OPEN SPACE ADVISORY COMMITTEE STAFF REPORT

MEETING DATE: February 22, 2016

REQUEST: **For Possible Action:** To approve the wetlands enhancement project at the old Buzzy's Ranch property as designed by Ducks Unlimited.

LAHONTAN VALLEY / WESTERN NEVADA WETLANDS I NAWCA - BUZZY'S RANCH PROJECT WETLAND RESTORATION / ENHANCEMENT

DEFINITIONS & LEGEND

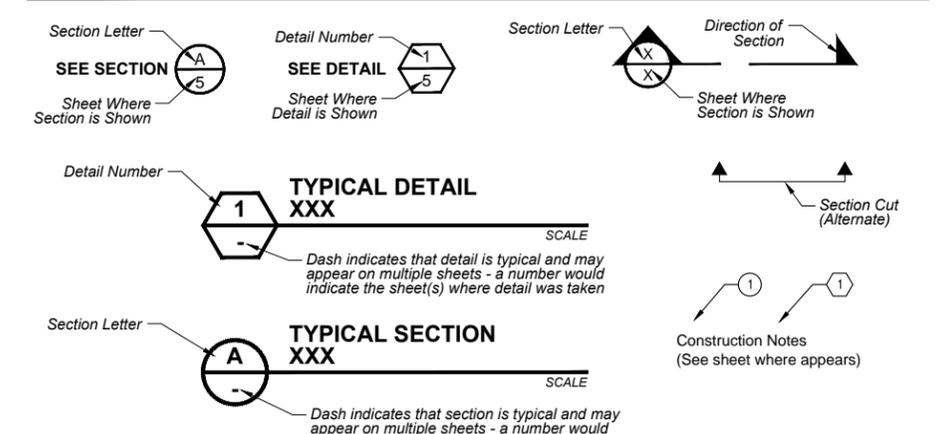
- Sheet No. 2 General notes. Please add #10: Carson City is the property owner and can be reached at (775) 887-2262. Contractor shall coordinate with property owner regarding construction access, dates and project status.

B
TYPICAL SECTION NEW ROAD
NOT TO SCALE

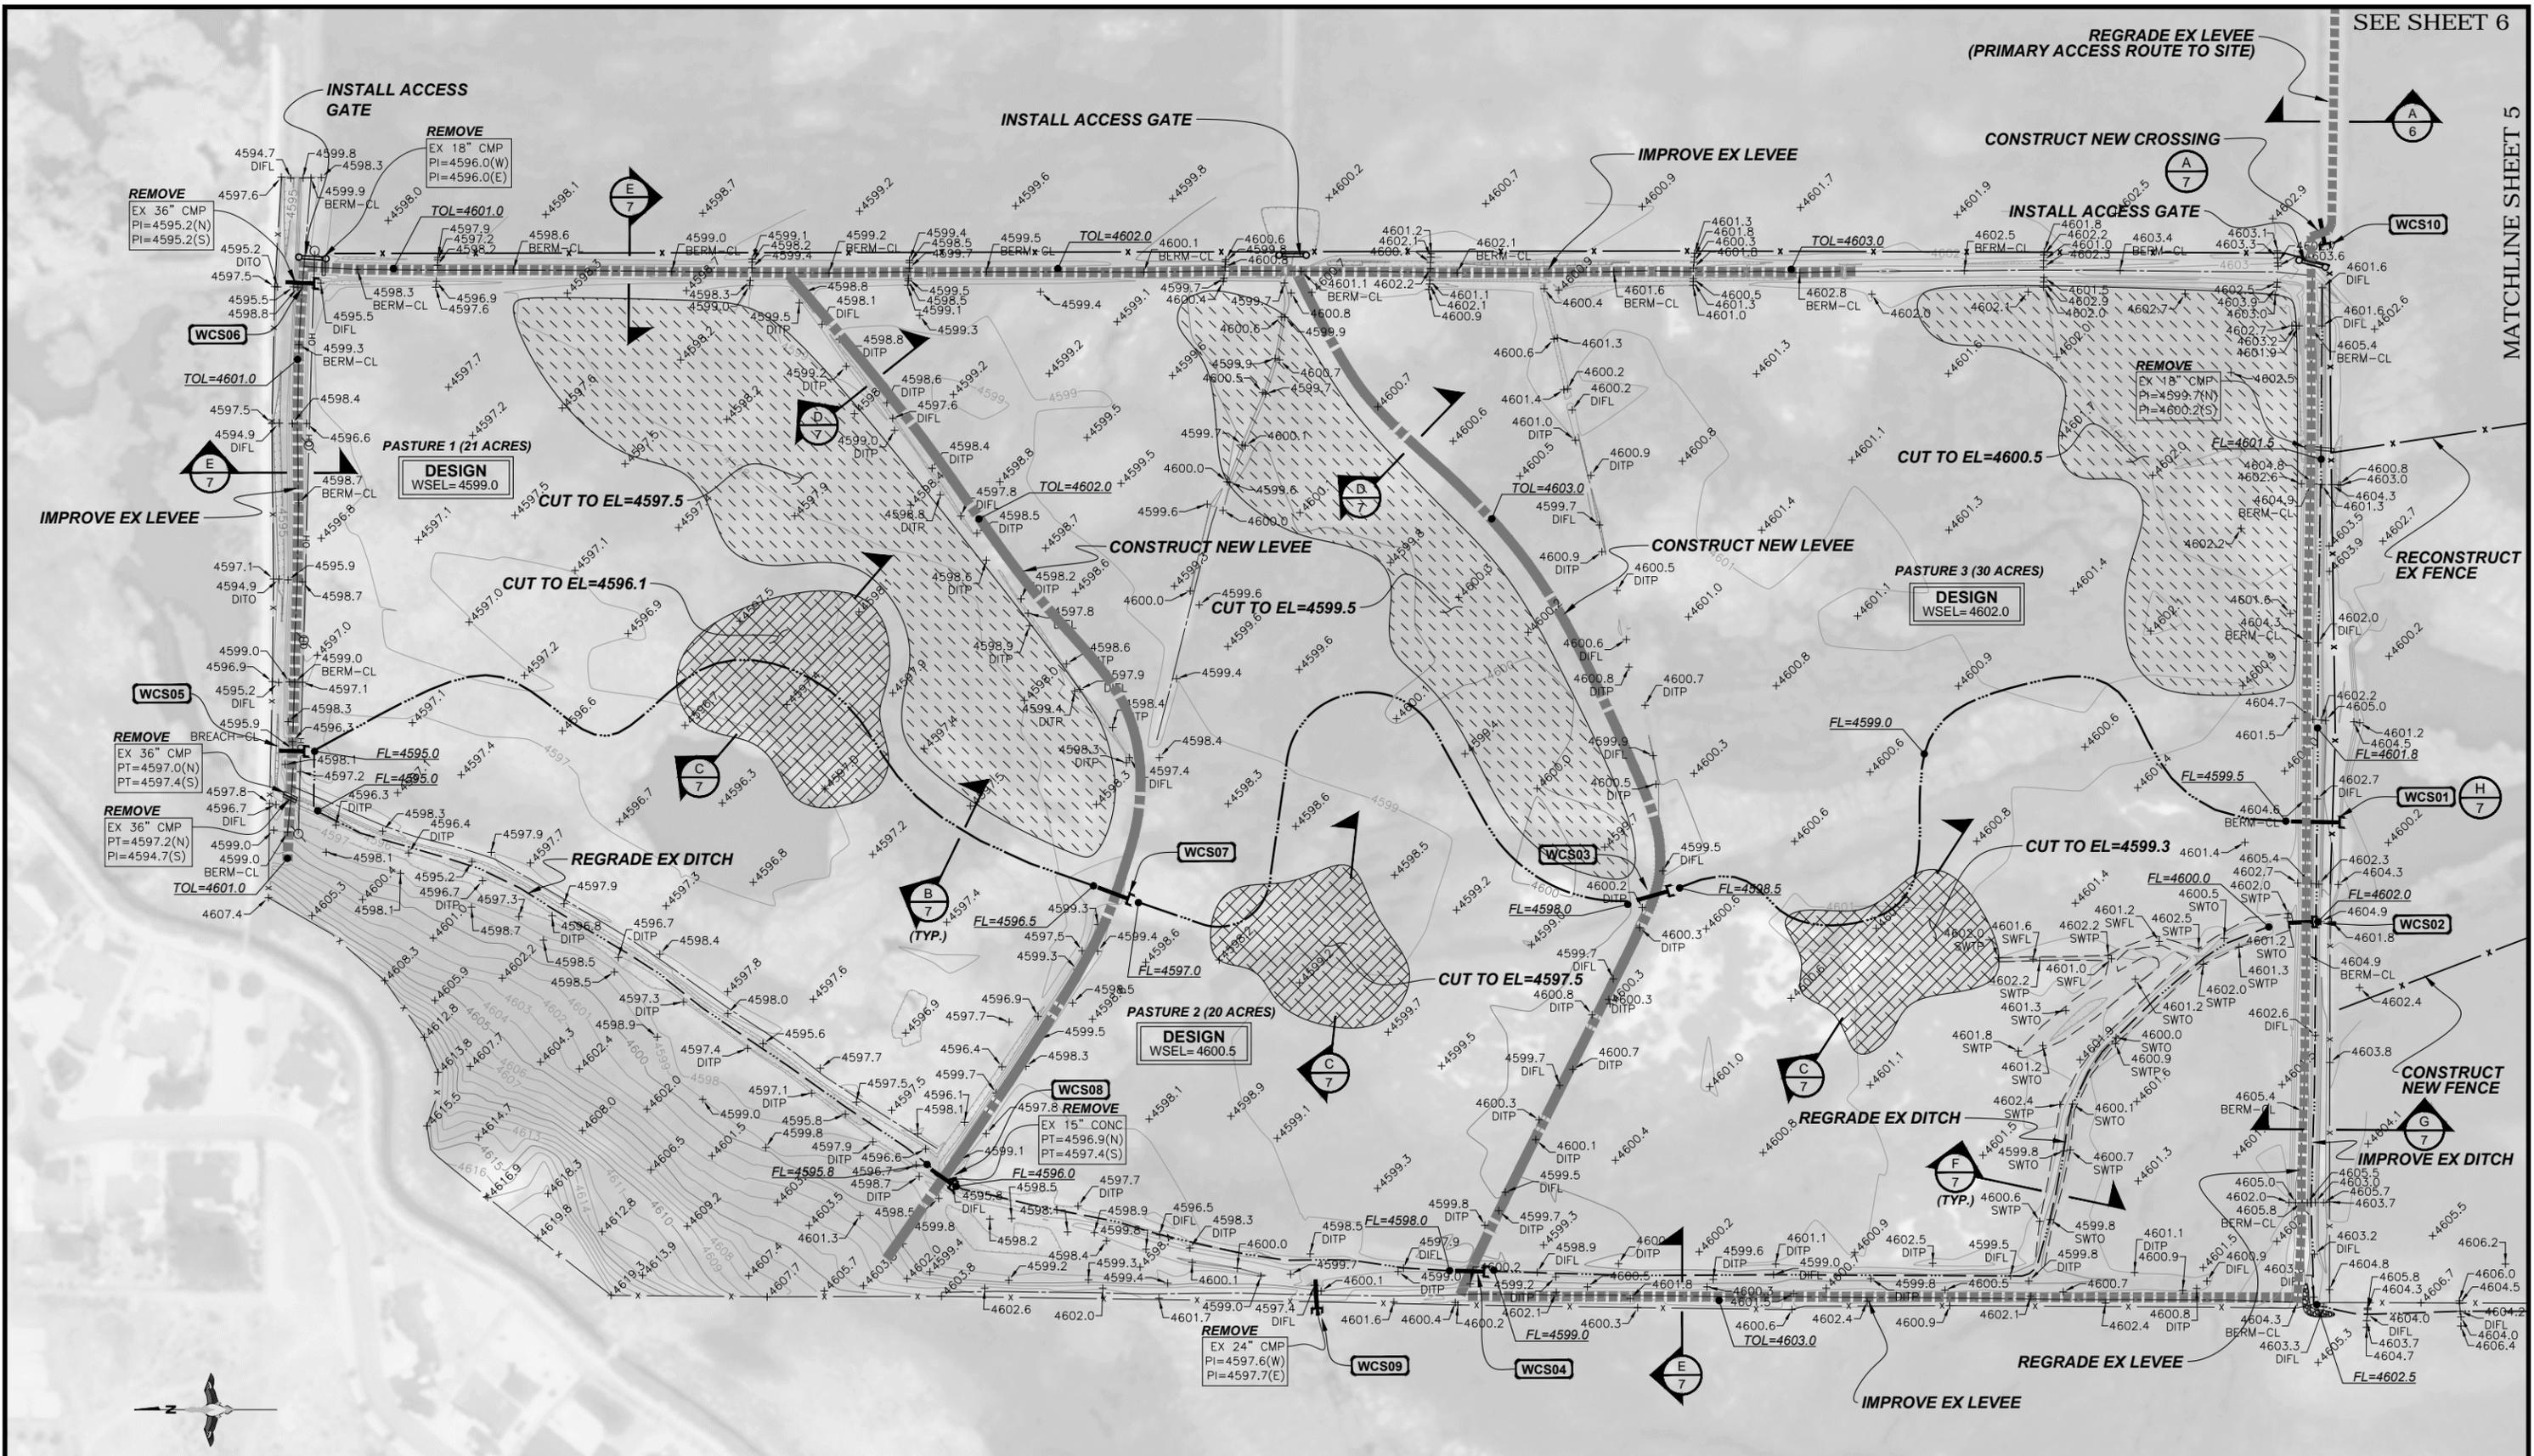
- The road shows 12'. What is the equipment that might be used on the road? If there is a possibility of anything bigger than a truck you might reconsider the size.

- Sheet No. 6. Change wording from typical section for new road to typical section repair of existing road. We do not want anyone to think we are creating a new road in the floodplain.

SITE PLAN SHEET NO. **4 of 7**

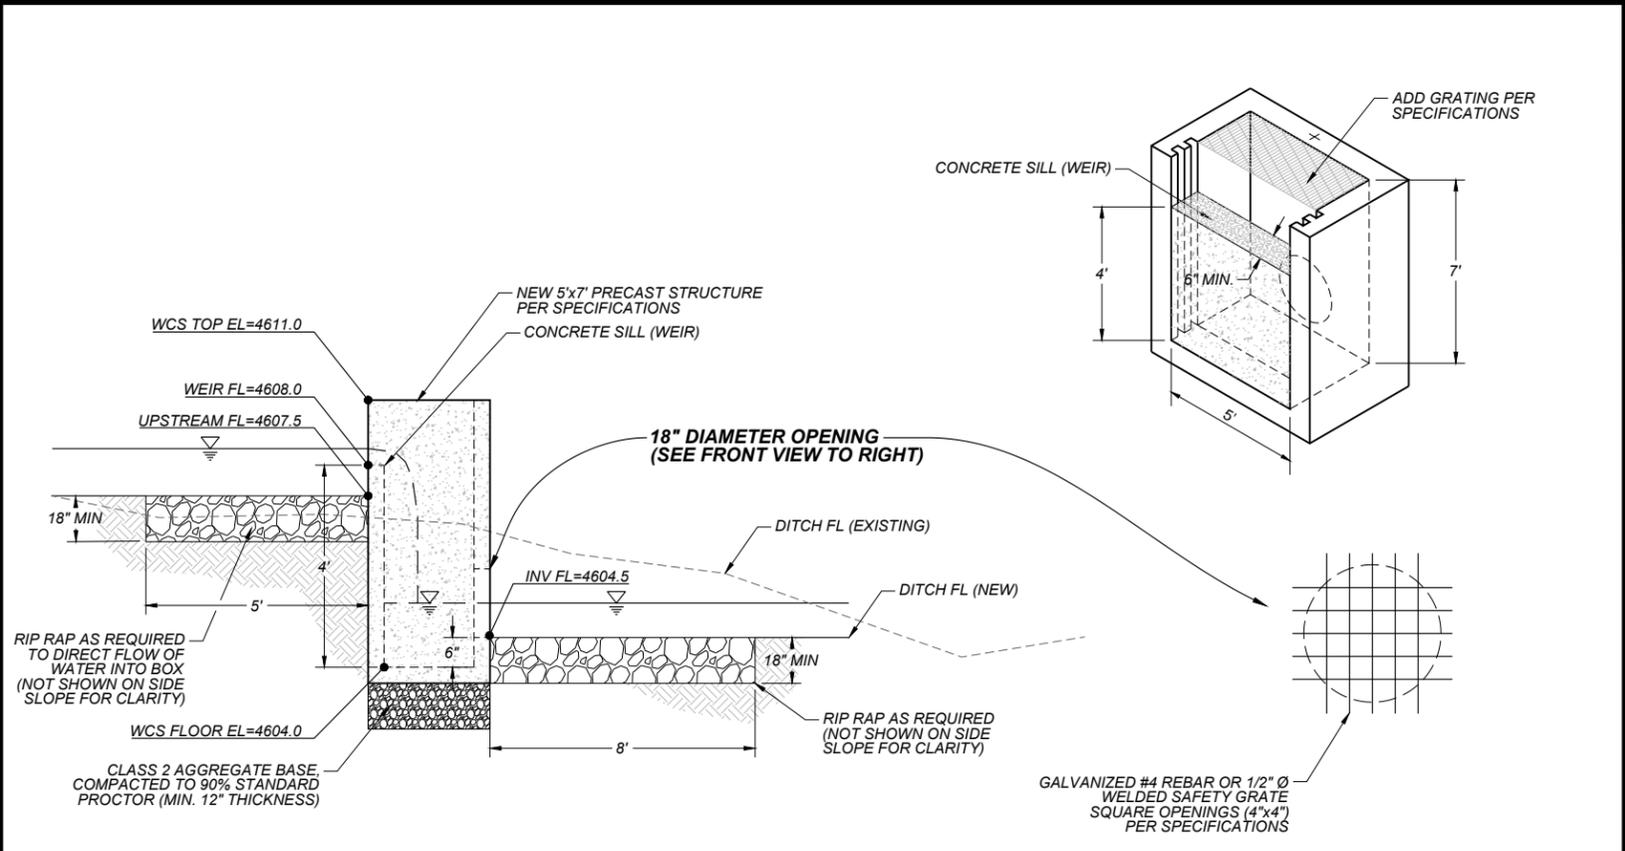
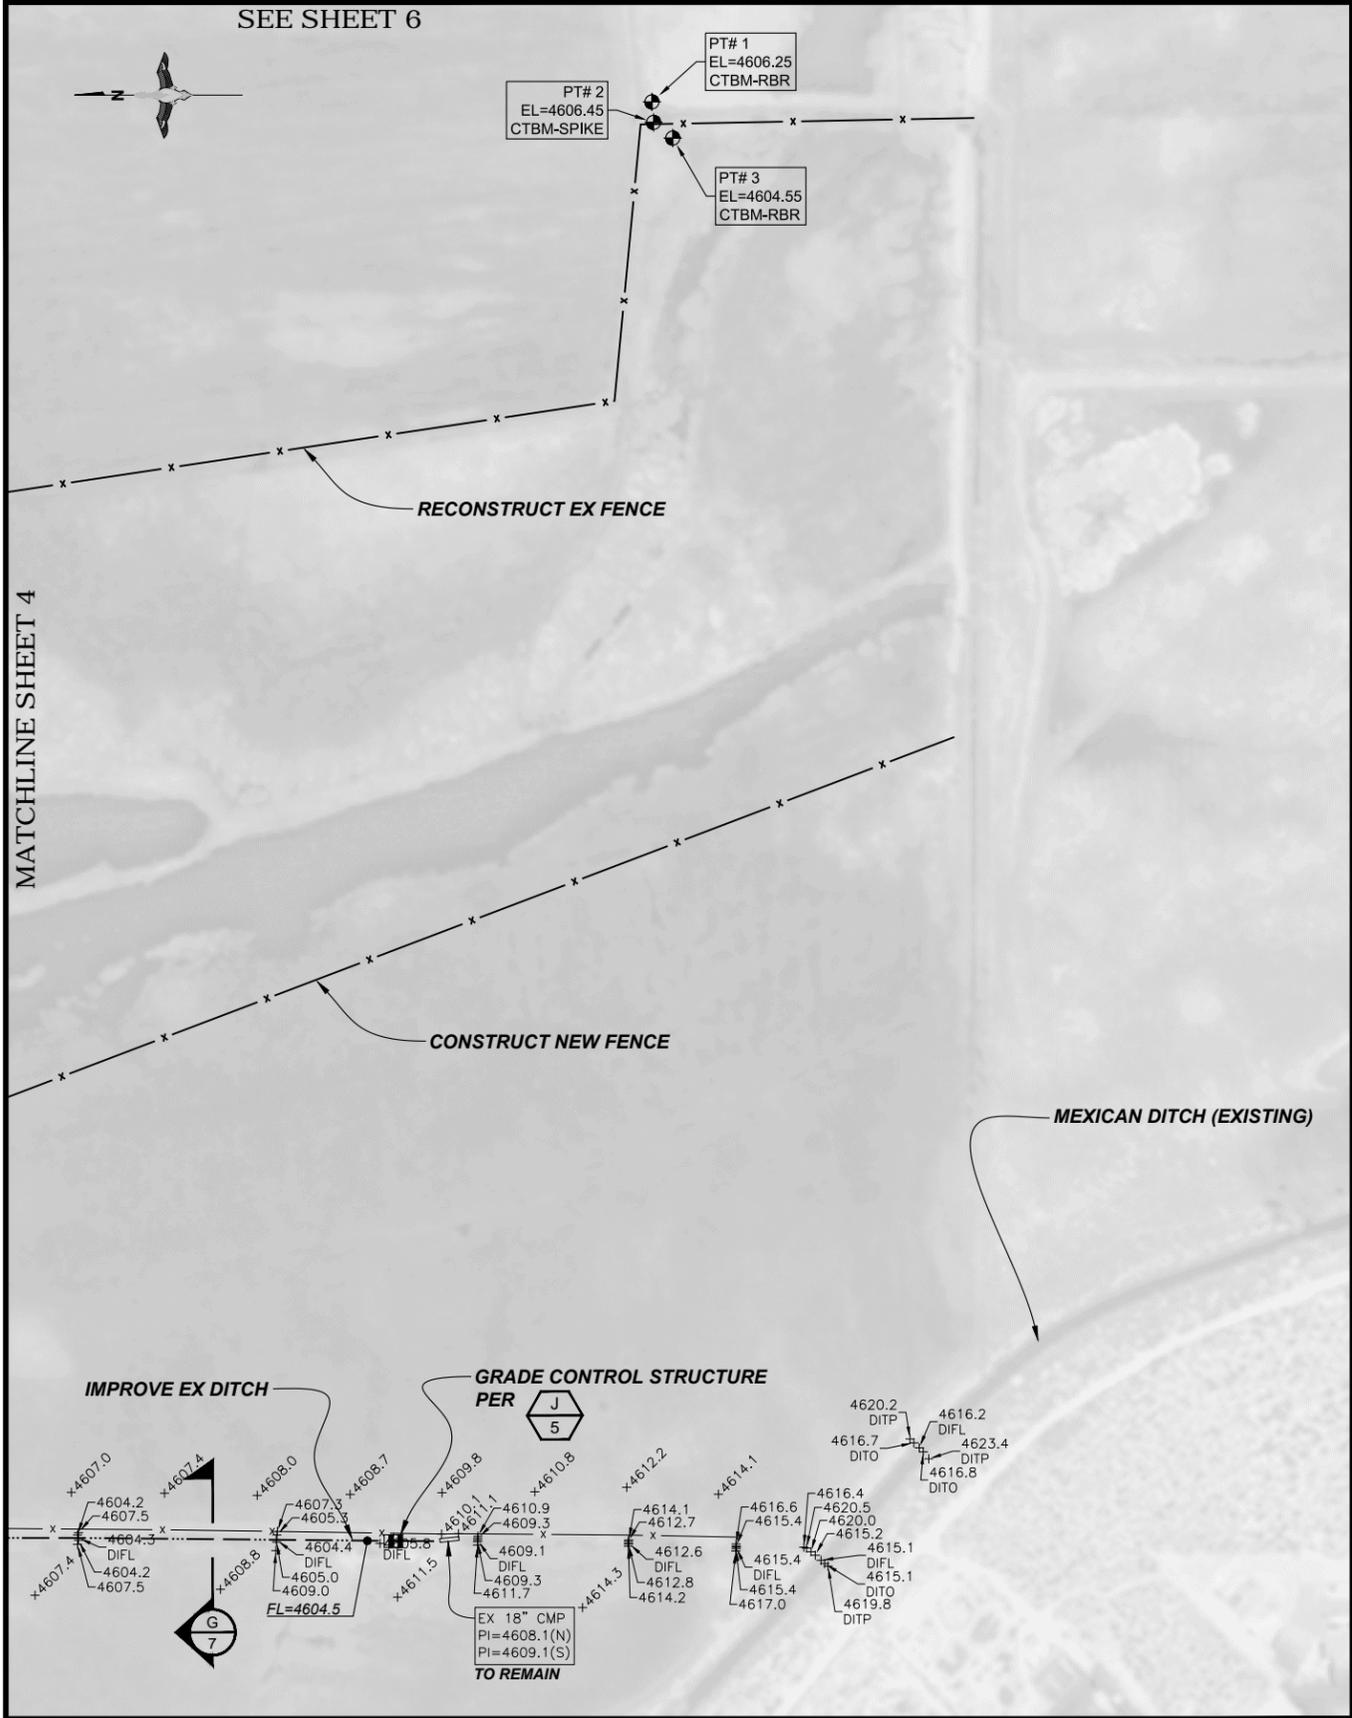
- Per review, it looks like the northwest cut area on page 4 with elevation 4597.5 is higher than some of the adjacent land elevations. This may be okay depending on your intent. However, it is the only area where the cut area was higher than some of the surrounding elevations. All the other cuts were lower than the surrounding elevations.
